# **Technical Bulletin**

Eliminating wind noises Subject:

Number: 94-01

Models(s): Passat

### Front doors at A-pillar

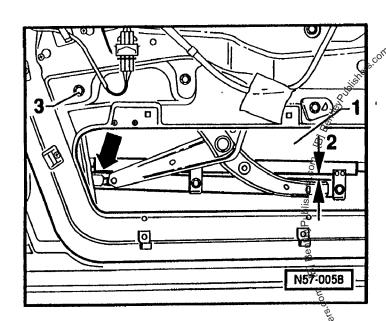
Resonance can occur at the outer/lower window - Pull off inner winds.

- Apply felt strip -2- (size 40 x 10 x 3 mm) Part No. 533 863 288 A, togrea indicated.

### Front doors with power windows

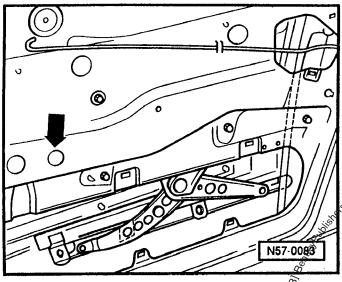
When the door windows are lowered, the door outer panel is pushed outward or the window slot seal is lifted up. The result is a roaring noise at the window slot.

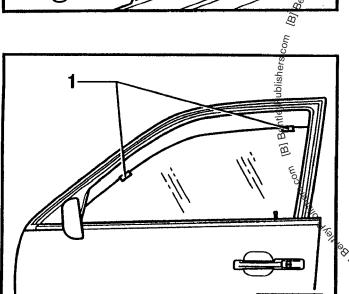
Check the setting of the door window and adjust if the cessary. hiecessary.

- Remove door trim panel and vapor barrier.
- Front of window -1- must be raised 2.0 mm from window regulator -2- and sit properly at the rear (arrow)
- Rear securing point -3- of lower guide rail must be set downward to the stop.
- Window must be aligned parallel to window guide.

The window must not be tilted forward as it could then pecome derance pecome become derailed from the window guide.

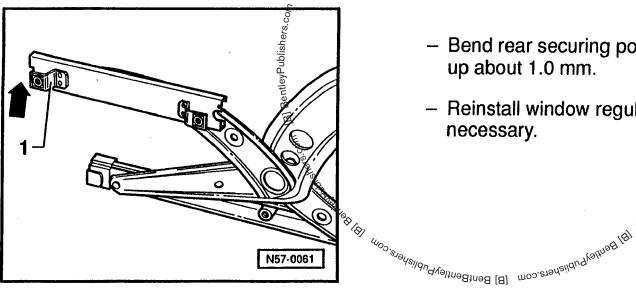
The window is tilted forward resulting in an insufficient seal to the outer window guide at the B-pillar (arrow).

- Check setting of window as described under "Front doors with power windows" on page 50–2. Adjust windows as Aerosary.
  - If window cannot be adjusted as described, remove window regulator.

# Doors - warped window guides

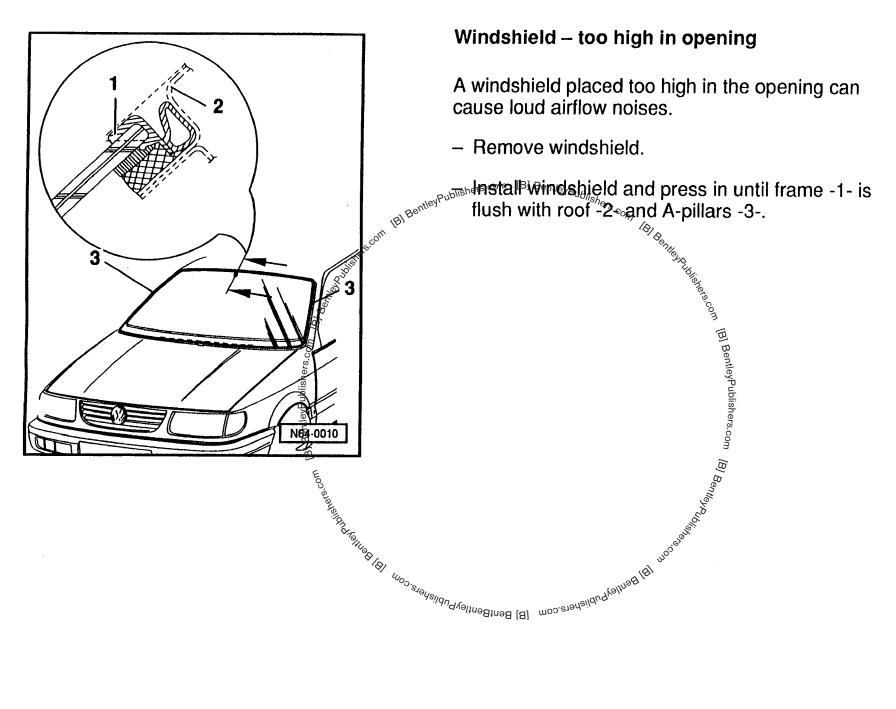
Loud airflow and resonance noises, especially at the B and C-pillars.

- Replace window guides -1-.

# Windshield - gap between glass and frame

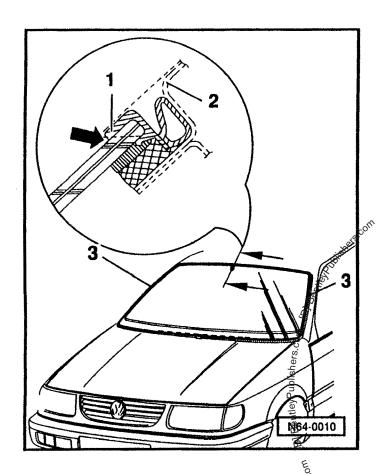
Loud roaring noises are produced if the windshield glass.

— Seal gap (arrow frame -1- is not evenly seated on the windshield

Seal gap (arrow) with sealant, Part No. D 001 007

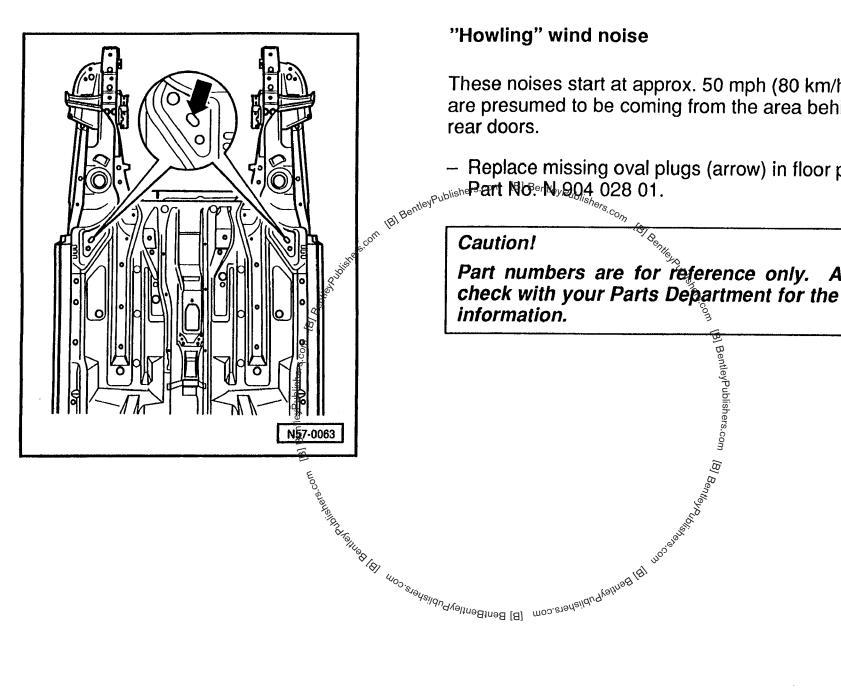
The modified position of the foot of the antenna can result in increased airflow noise at the antenna rod.

- Replace antenna with Part No. 1H0 035 503 C.
